SPOKANE		gn Review Board October 23, 2019 5:30-8:00 PM City Council Briefing Center	
TIMES GIVEN ARE AN ESTIMATE AND ARE SUBJECT TO CHANGE			
	Board Briefing Session:

6:15 – 7:30	<ul> <li>7) <u>Recommendation Meeting for SportsPlex</u></li> <li>Staff Report</li></ul>	Dean Gunderson	
	Adjournment:		
The next Design Review Board meeting is scheduled for November 13 <sup>rd</sup> , 2019.

- 1. Collaborative Workshop for SportsPlex
  - Staff Report: Dean Gunderson
  - Applicant Presentation & Additional Comments: Colin Anderson (Integrus Architecture), Dave Nelson (Land Expressions), Melissa Huggins (Spokane Arts)
  - Questions asked and answered
  - Discussion ensued

Figure 1. Design Guidelines Connections for SportsPlex

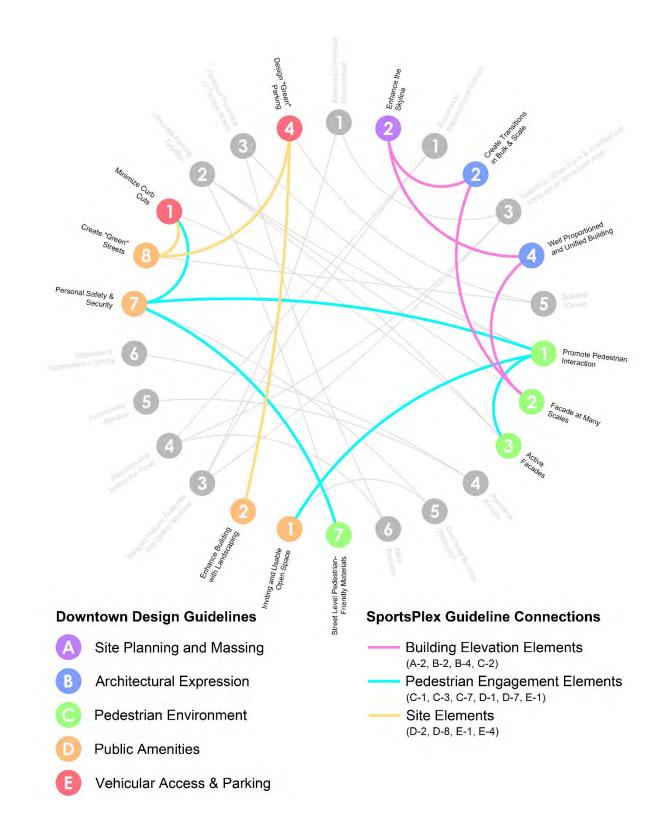
The following figure and topics for discussion are based on the prior Advisory Actions and Recommendations the Design Review Board provided the applicant (see Figure 1 and Table 1).

The image below depicts the façades which exceed 50' and are conceivably visible from a street (based upon site plan received Feb. 20).

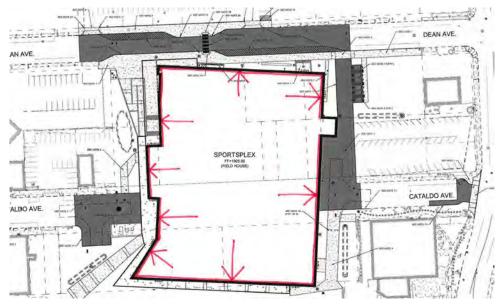
• How might portions of the building façade which exceed 50' in length fulfill the purpose of this design standard and meet the requirements of articulation implementation?

# WEST ELEVATION

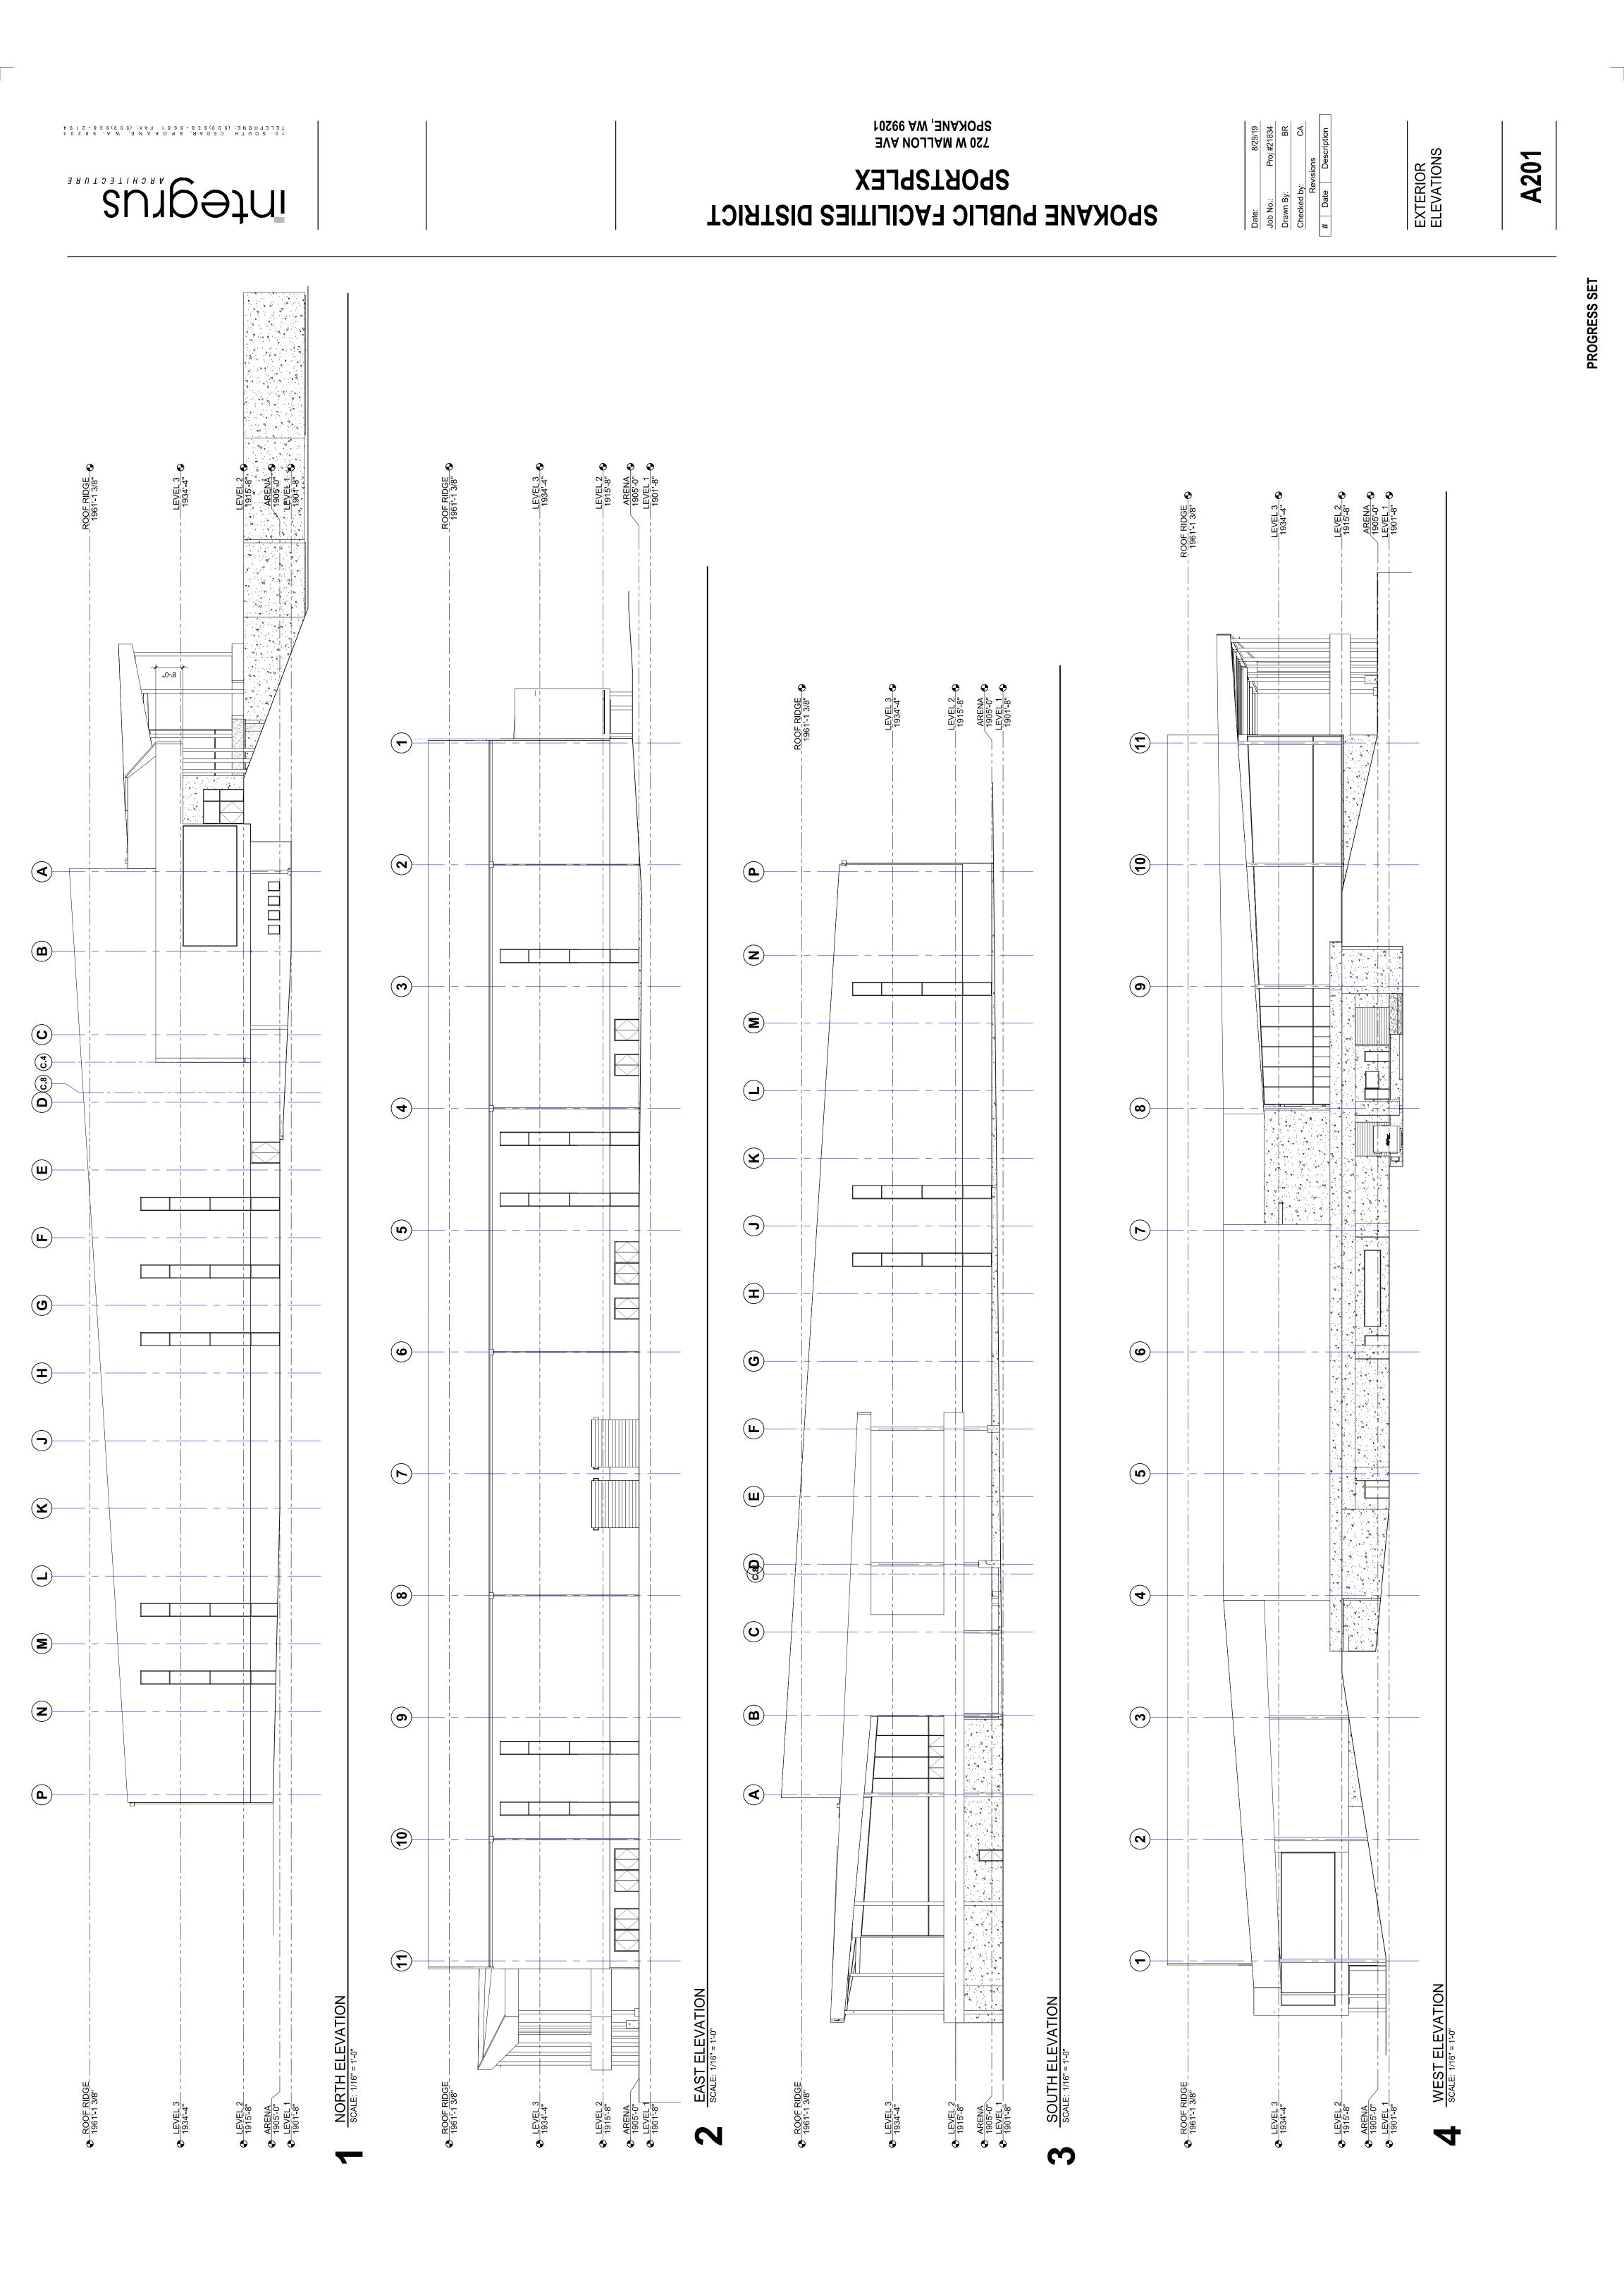
- 1. The applicant shall further explore additional options for façade articulation according to SMC 17C.124.530.
  - a. SMC17C.124.530 Purpose.
    - To reduce the massiveness of larger buildings.
